SUSQUEHANNA STEAM ELECTRIC STATION, UNIT 1

AMENDMENT TO FACILITY OPERATING LICENSE

Amendment No. 93  
License No. NPF-14

Date of Issuance: November 20, 1989

**FIGURE 3.4.1.1-1  
THERMAL POWER RESTRICTIONS**

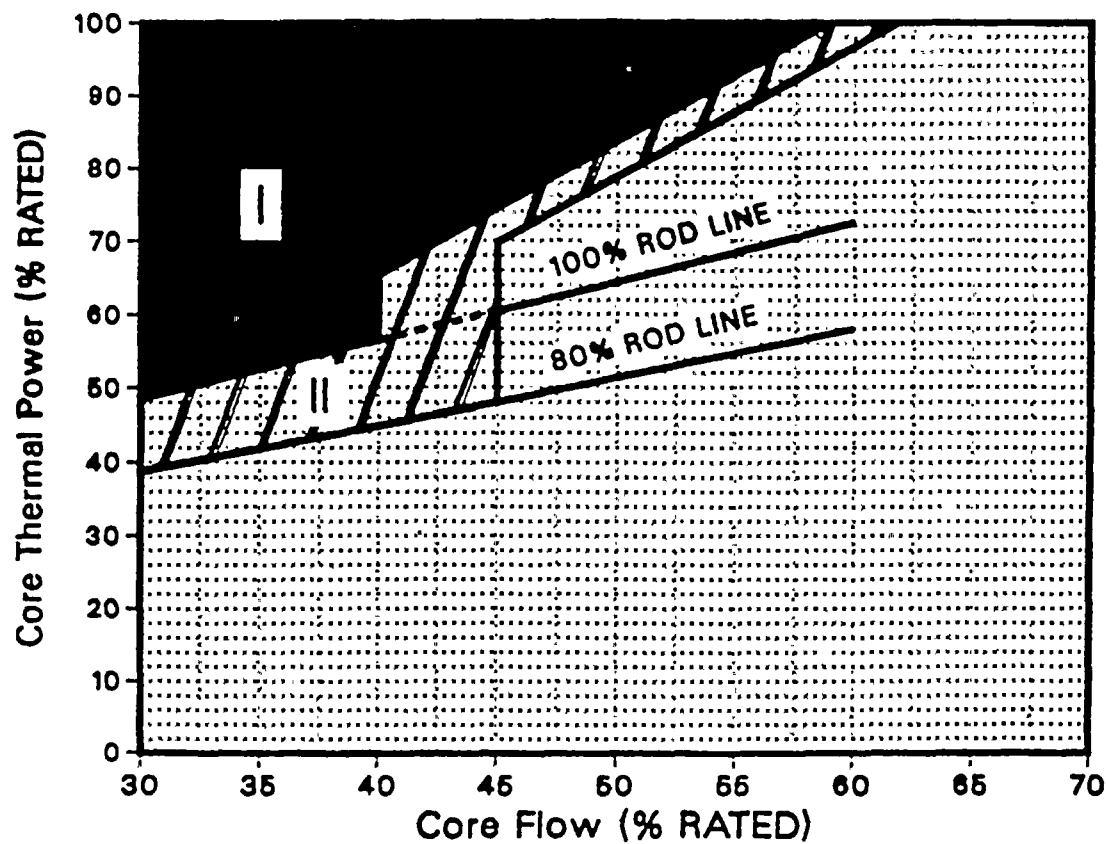
3.4.1.1.1 Two reactor coolant system recirculation loops shall be in operation with the reactor at a THERMAL POWER/coreflow condition outside of Regions I and II of Figure 3.4.1.1.1-1.

- a) No reactor coolant system recirculation loops in operation, or
- b) Region I of Figure 3.4.1.1.1-1 entered, or
- c) Region II of Figure 3.4.1.1.1-1 entered and core thermal hydraulic instability occurring as evidenced by:
  - 1) Two or more APRM readings oscillating with at least one oscillating greater than or equal to 10% of RATED THERMAL POWER peak-to-peak, or
  - 2) Two or more LPRM upscale alarms activating and deactivating with a 1 to 5 second period, or
  - 3) Observation of a sustained LPRM oscillation of greater than 10 w/cm<sup>2</sup> peak-to-peak with a 1 to 5 second period, or
- d) Region II of Figure 3.4.1.1.1-1 entered and less than 50% of the required LPRM upscale alarms OPERABLE,  
immediately place the reactor mode switch in the shutdown position.

2. If Region II of Figure 3.4.1.1.1-1 is entered and greater than or equal to 50% of the required LPRM upscale alarms OPERABLE, immediately exit the region by:

- a) inserting a predetermined set of high worth control rods, or
- b) increasing core flow.

3.4.1.1.2 One reactor coolant recirculation loop shall be in operation with the pump speed  $\leq 80\%$  of the rated pump speed and the reactor at a THERMAL POWER/core flow condition outside of Regions I and II of Figure 3.4.1.1.1-1, and

Specifications have been provided to prevent, detect, and mitigate core thermal hydraulic instability events. These specifications are prescribed in accordance with NRC Bulletin 88-07, Supplement 1, "Power Oscillations in Boiling Water Reactors (BWRs)," dated December 30, 1988. The boundaries of the regions in Figure 3.4.1.1.1.1-1 are determined using ANF decay ratio calculations and supported by Susquehanna SES stability testing.
